# Intel<sup>®</sup> StrongARM<sup>\*</sup> SA-1110 Microprocessor

Specification Update

*April 2001*

Order Number: 278259-022

Figure 9-2. Interrupt Controller Block Diagram

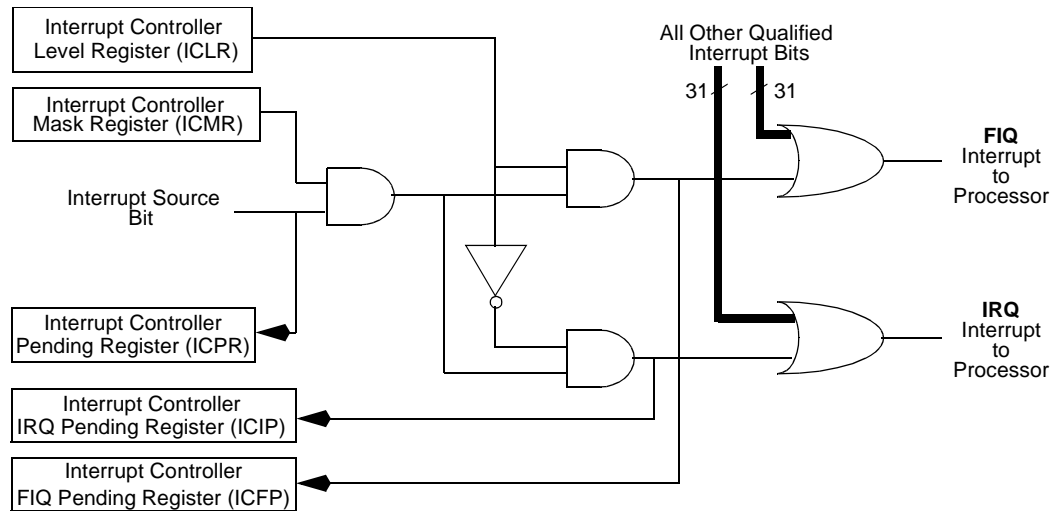
Made the following changes to Figure 9-2.

- Changed Interrupt Level Register to Interrupt Controller Level Register (ICLR)
- Changed Interrupt Mask Register to Interrupt Controller Mask Register (ICMR)
- Changed Interrupt Pending Register to Interrupt Controller Pending Register (ICPR)
- Changed IRQ Interrupt Pending Register to Interrupt Controller IRQ Pending Register (ICIP)
- Changed FIQ Interrupt Pending Register to Interrupt Controller FIQ Pending Register (ICFP)

Figure 9-2 now appears as:

Corrected Figure 11-2.

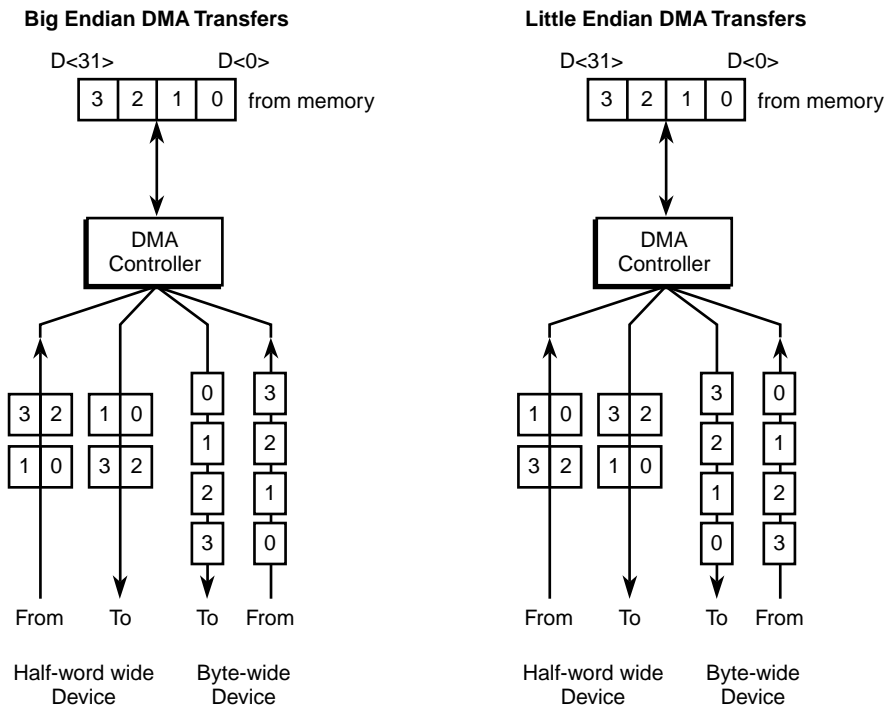
**51. DMA Device Address Register (DDARn): Section 11.6.1.1**

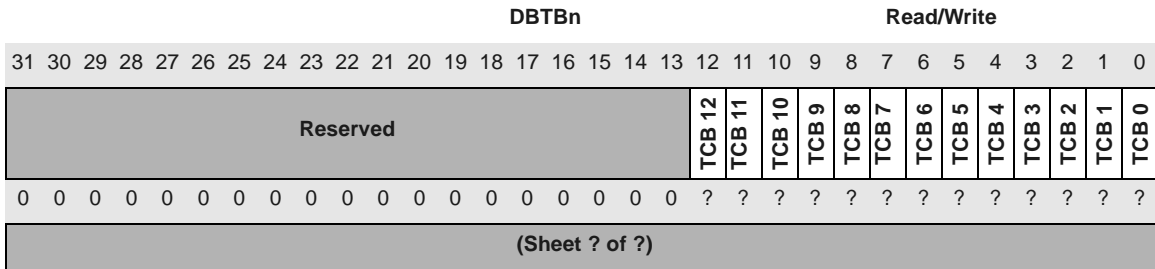
Changed DMA Buffer A Transfer Count register reset values for the Reserved bits to 0.

Figure 11-10. Passive Mode Beginning-of-Frame Timing

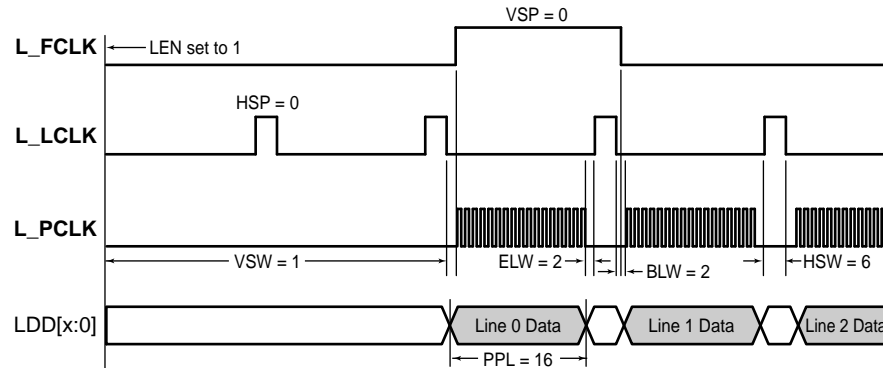
Changed the Notes: in Figure 11-10 to show the range of HSW as 1 to 64, not 0 to 64. The corrected figure is shown below:

Figure 11-11. Passive Mode End of Frame Timing

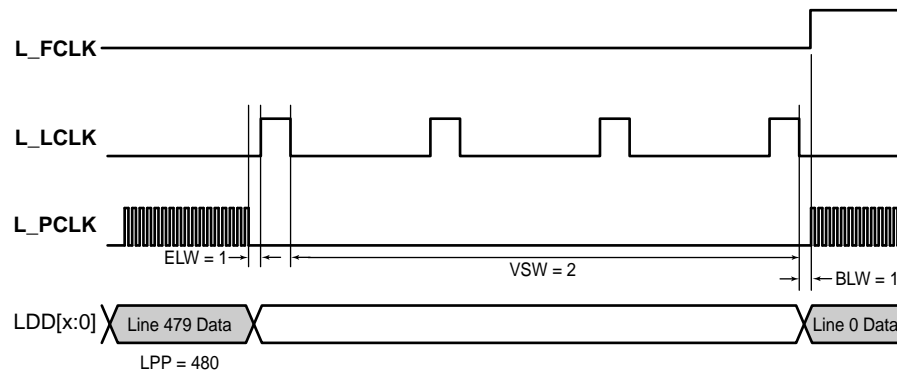
In Figure 11-11 at the location where L\_LCLK is deasserted just prior to Line 0 Data, there are two vertical bars depicting BLW = 1. Extended the right vertical bar upward to near L-LFCLK. At this point, changed L\_FCLK to show a transition from deasserted to asserted (shown below.)

Also, changed the Notes: in Figure 11-11 to show the range of BLW as 1 to 256, not 0 to 256. The corrected figure is shown below:

Figure 11-13. Active Mode Timing

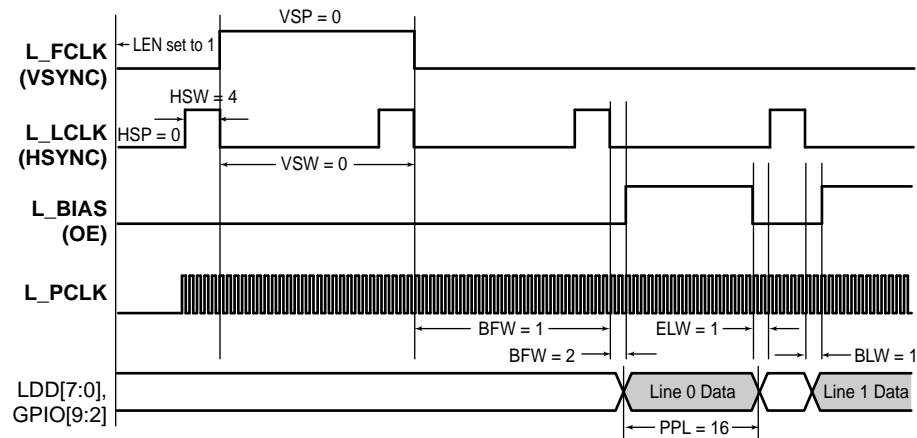
Corrected Notes: in Figure 11-13 to show the range of PPL as 16 to 1024 (not 1 to 1024.) The corrected figure is shown below:
